# Conceptual Review Agenda

Schedule for 02/04/13 to 02/04/13

# 417 N Grant Ave Subdivide & SF Homes

# I-25 & Carpenter Rd

K U M & G O P R O T O T Y P E G A S C A N O P Y

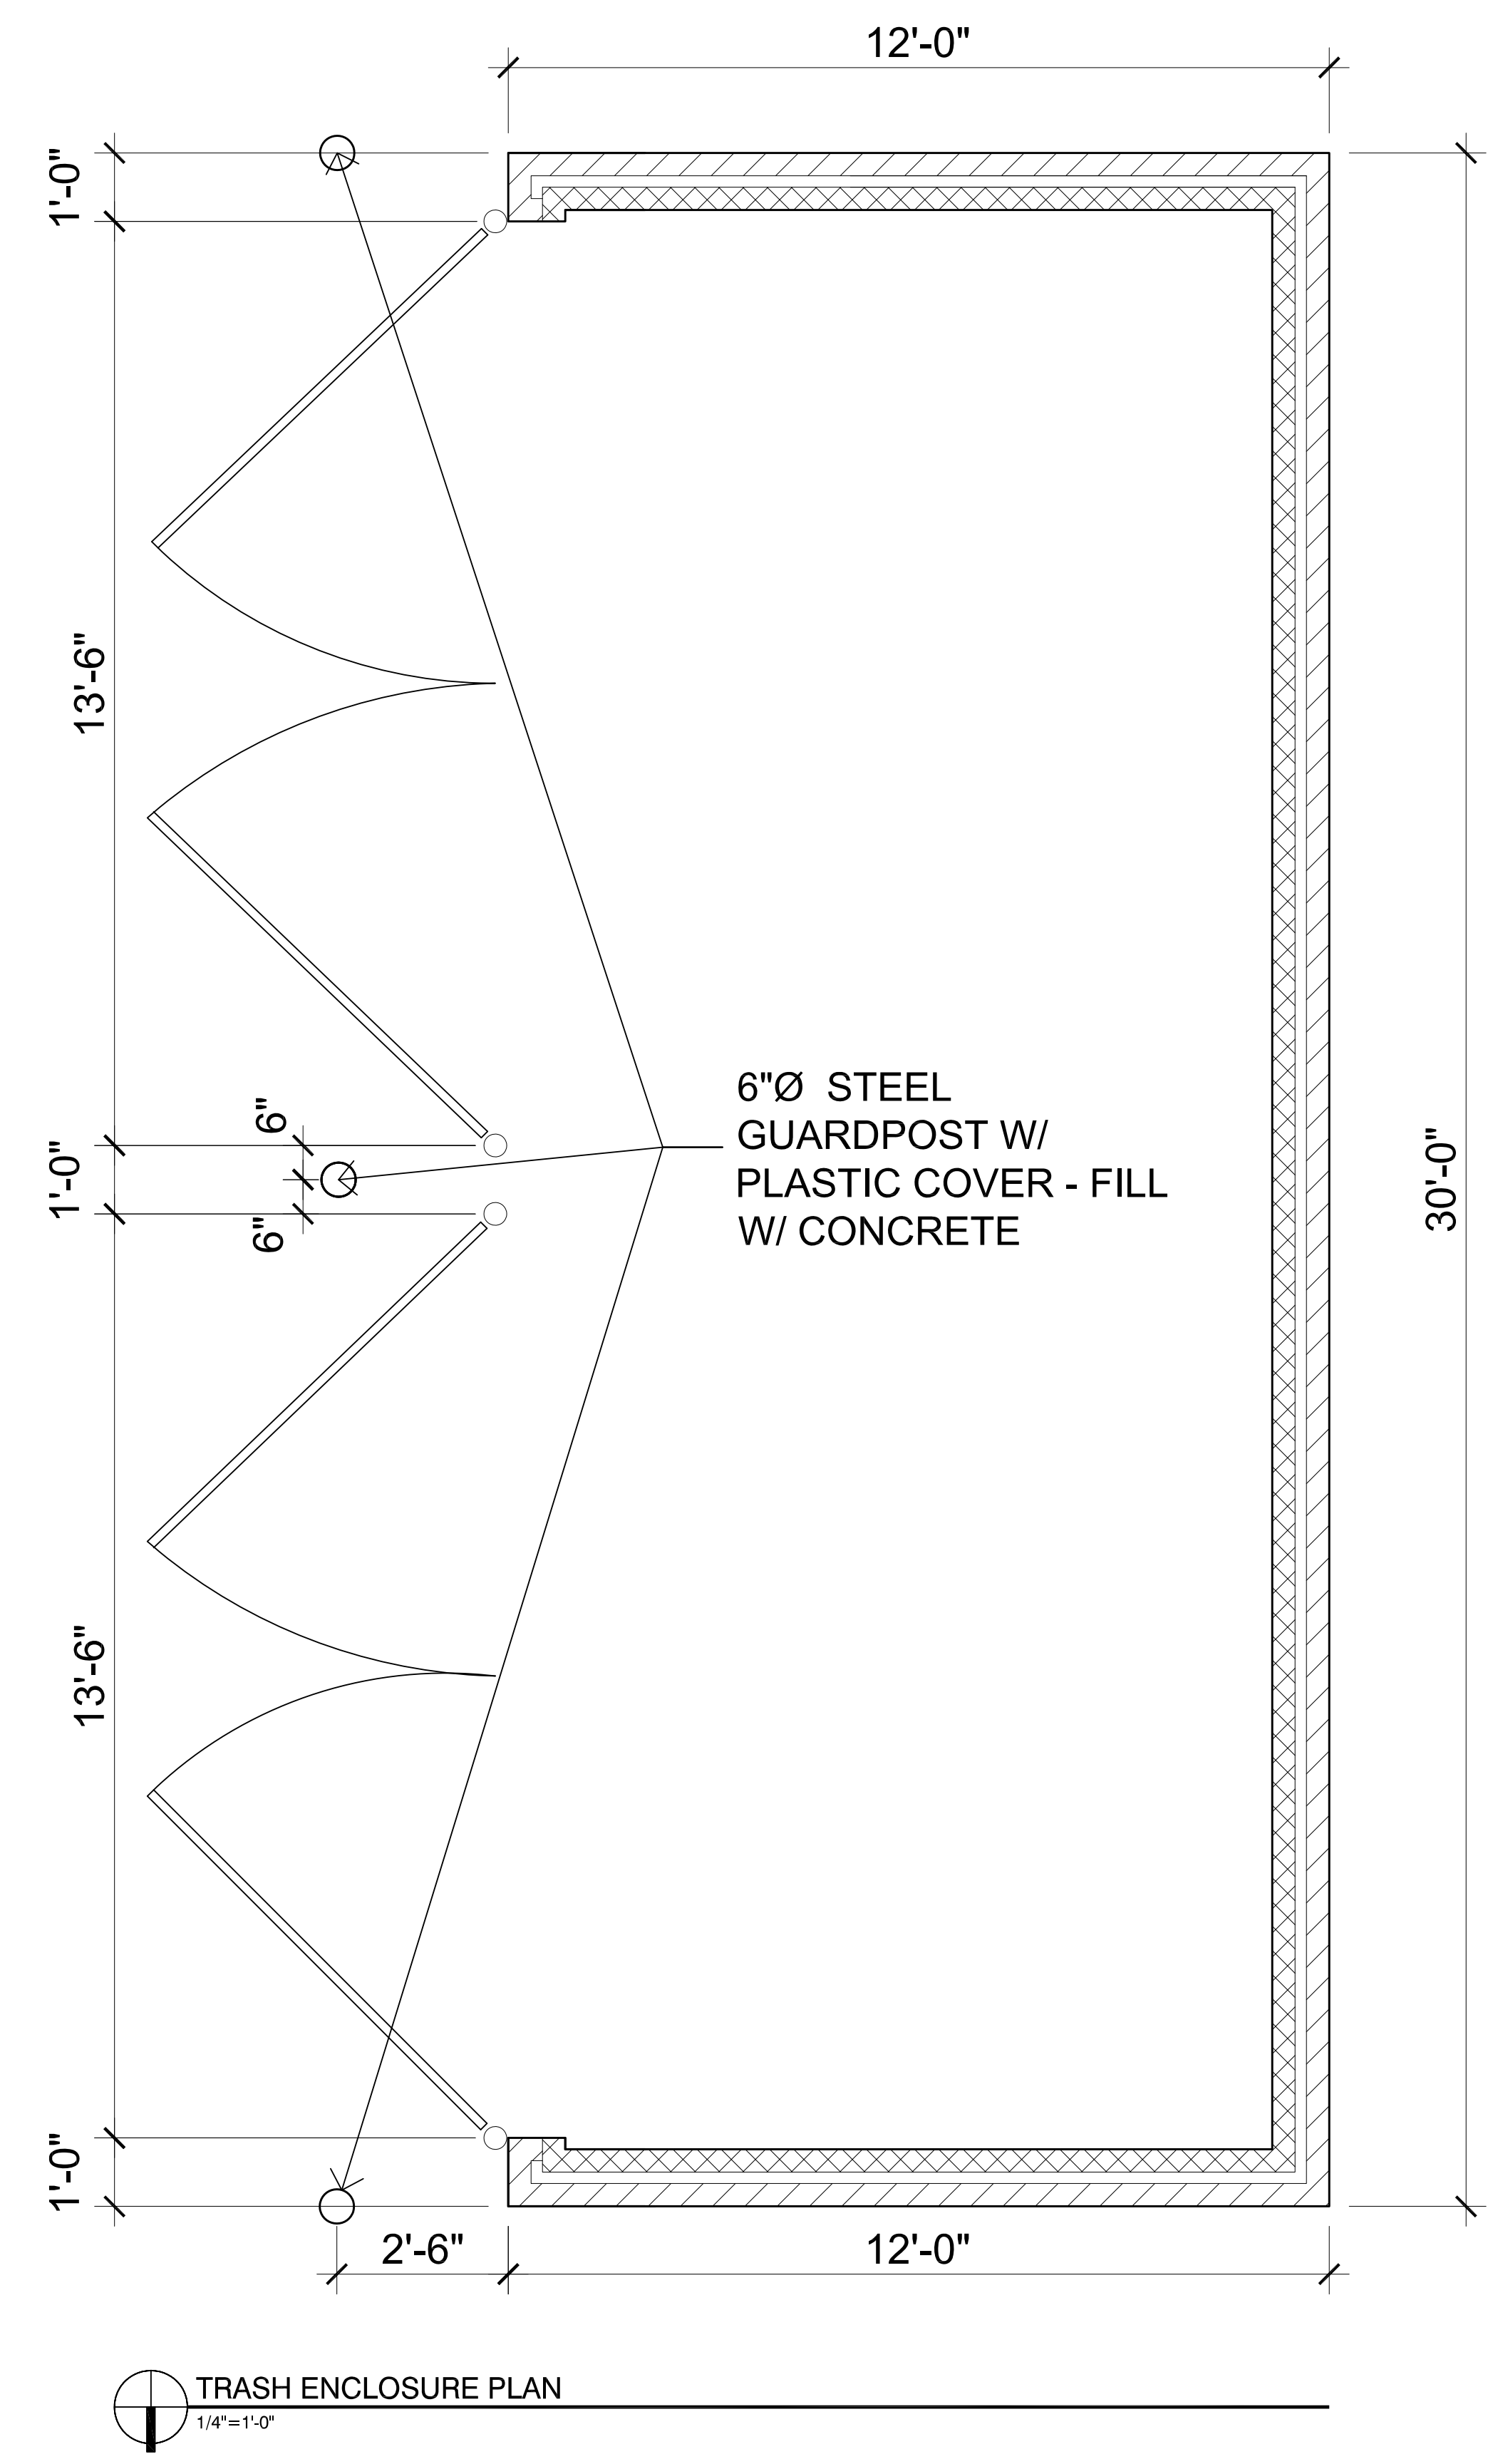
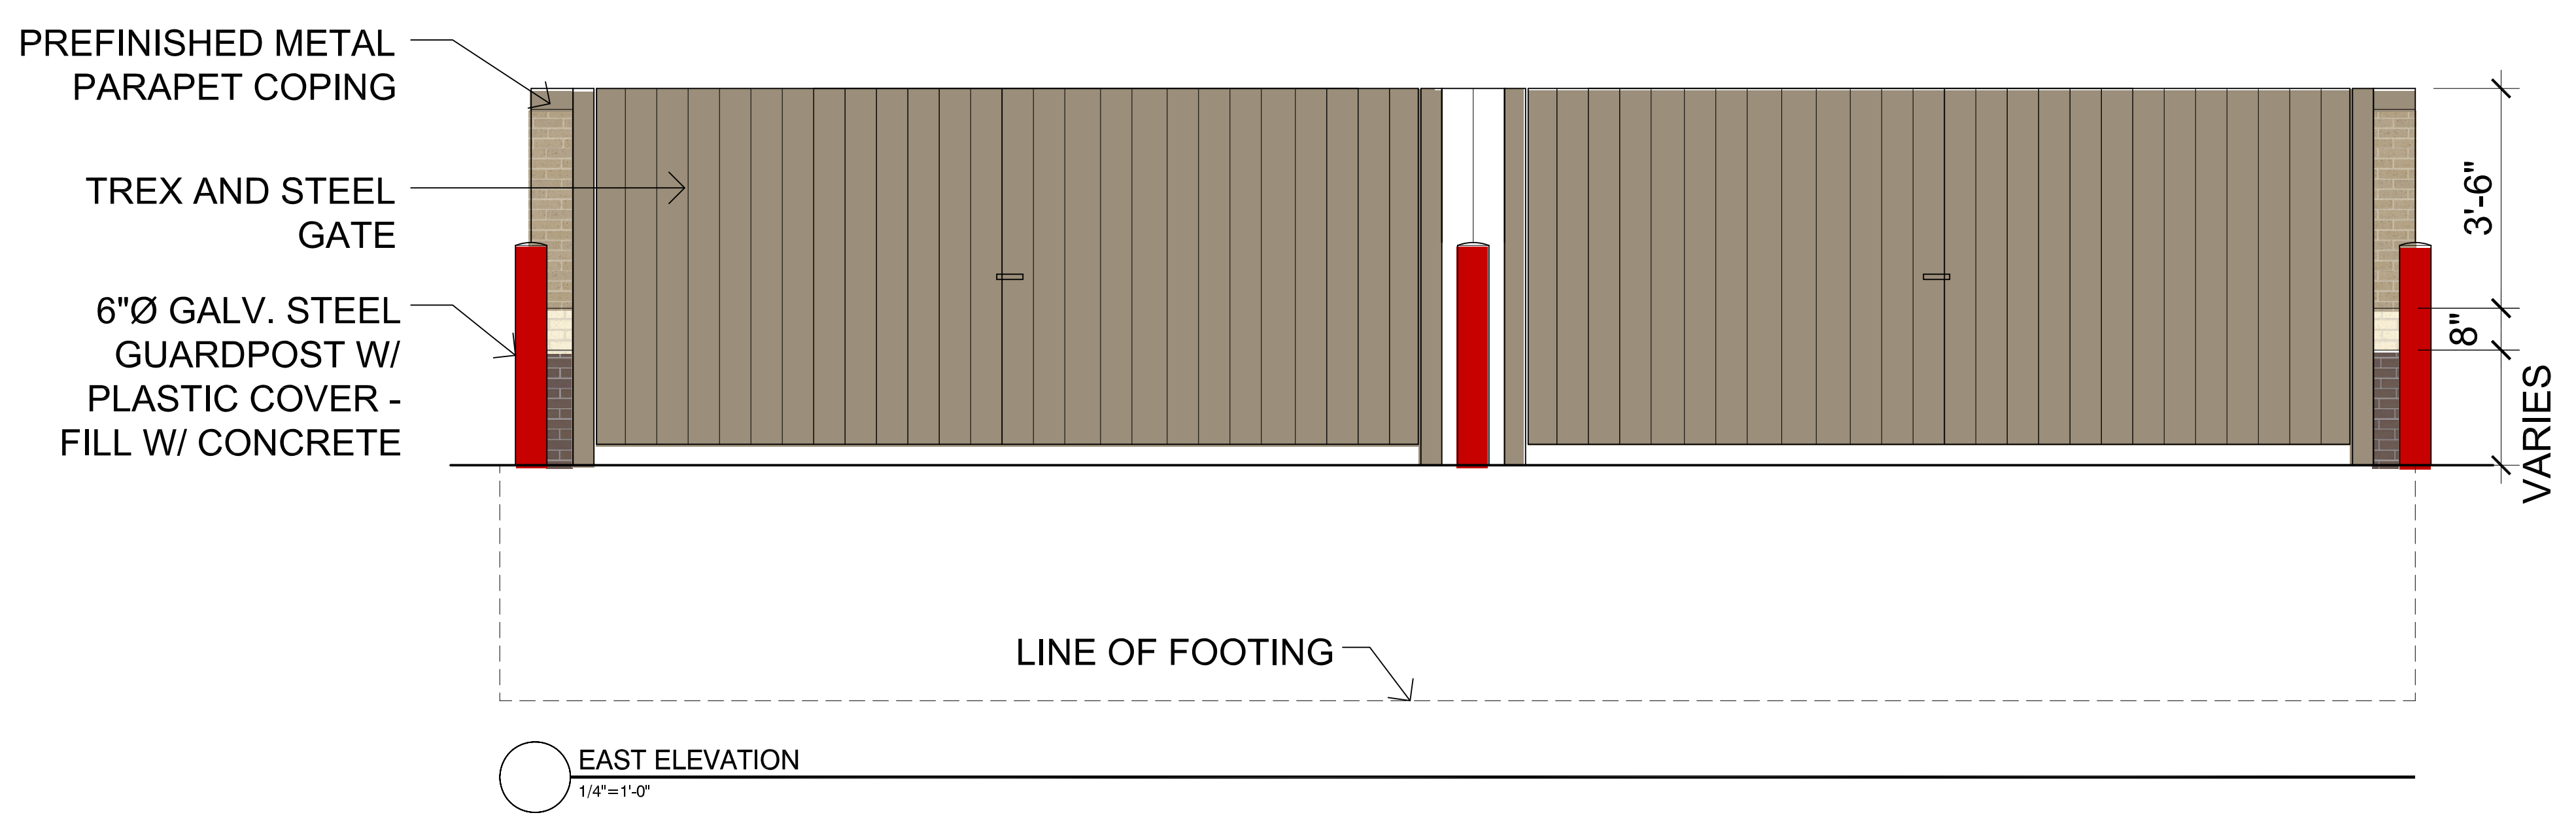
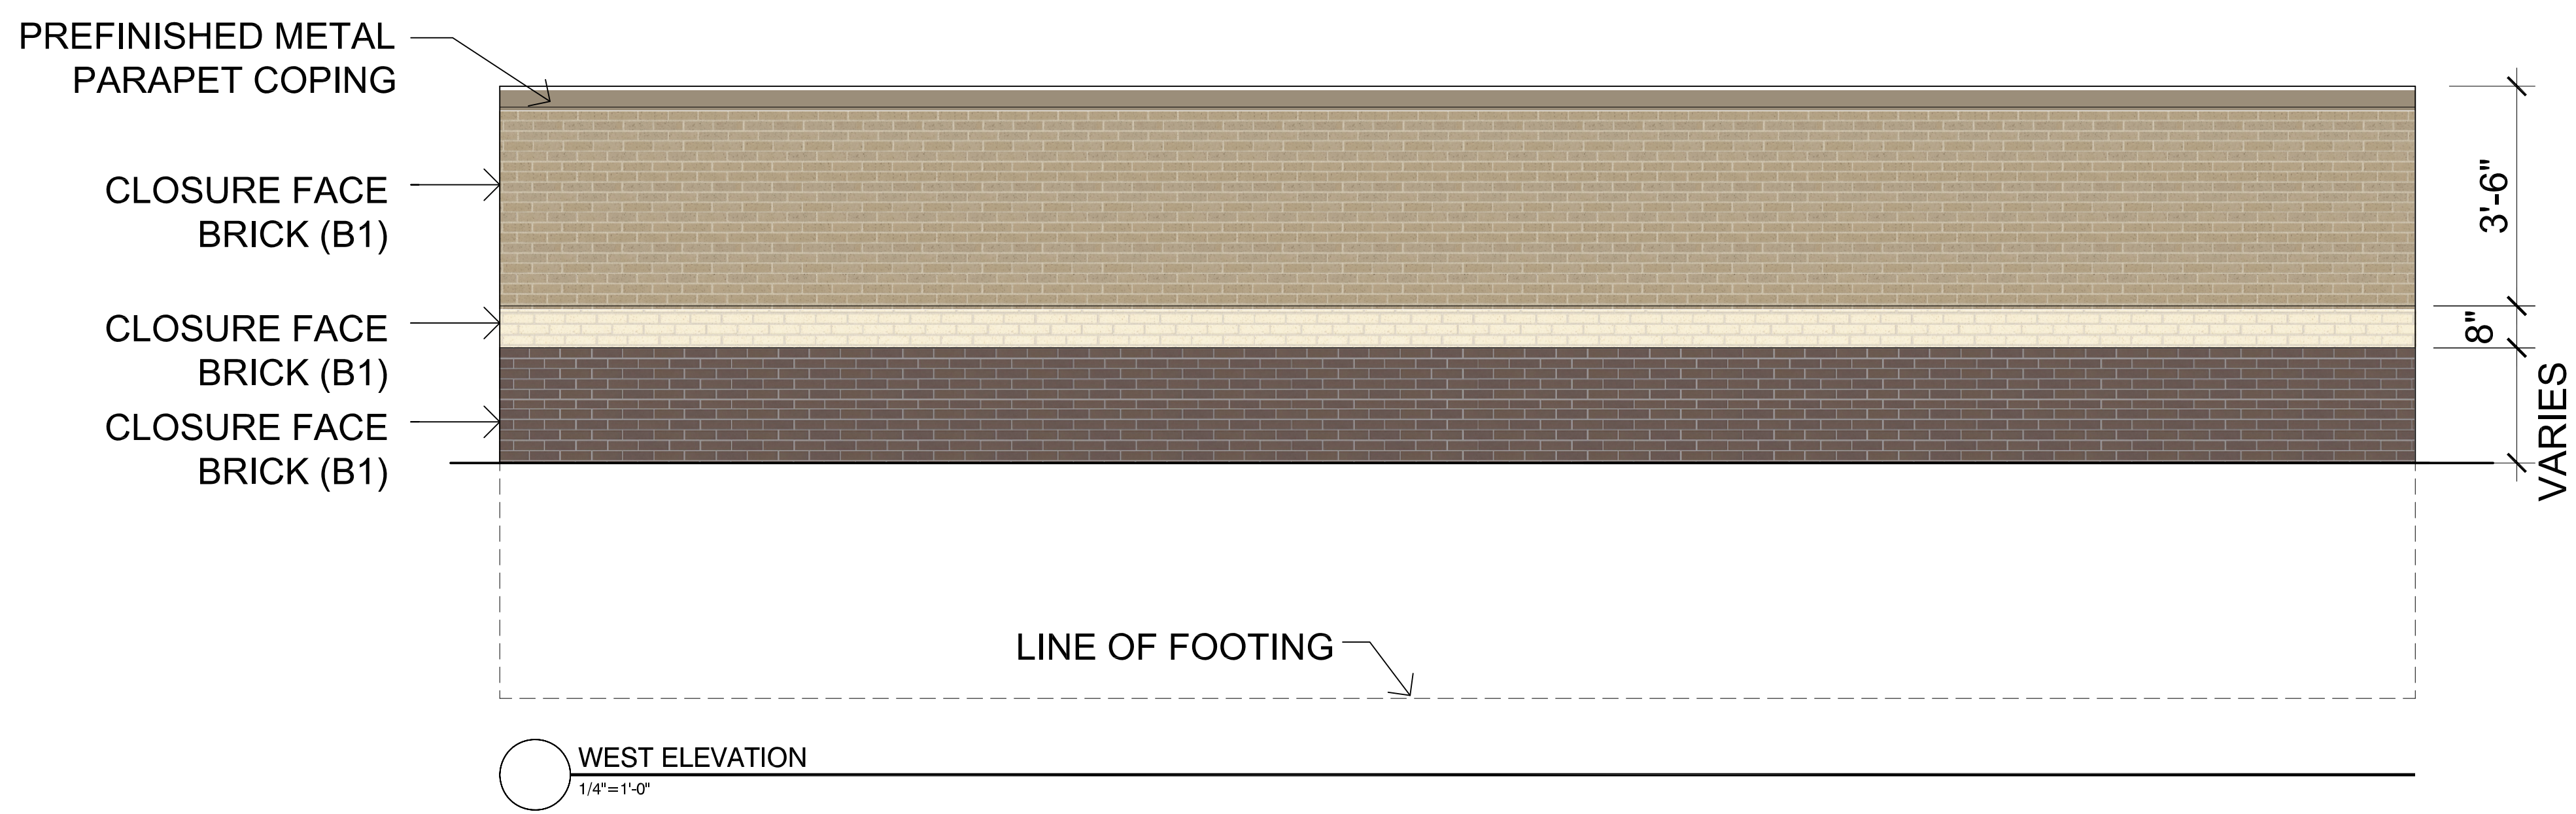
10. Please note that Section 3.5.3(D)(4) allows for the modification of a standardized prototype design in order to promote a distinctive urban design for the Corridor Activity Center. With regard to the canopy, therefore, white painted columns would need to be re-designed to feature the masonry material used on the building. Also, Section 3.9.5(C) requires colors to be of low reflectance.
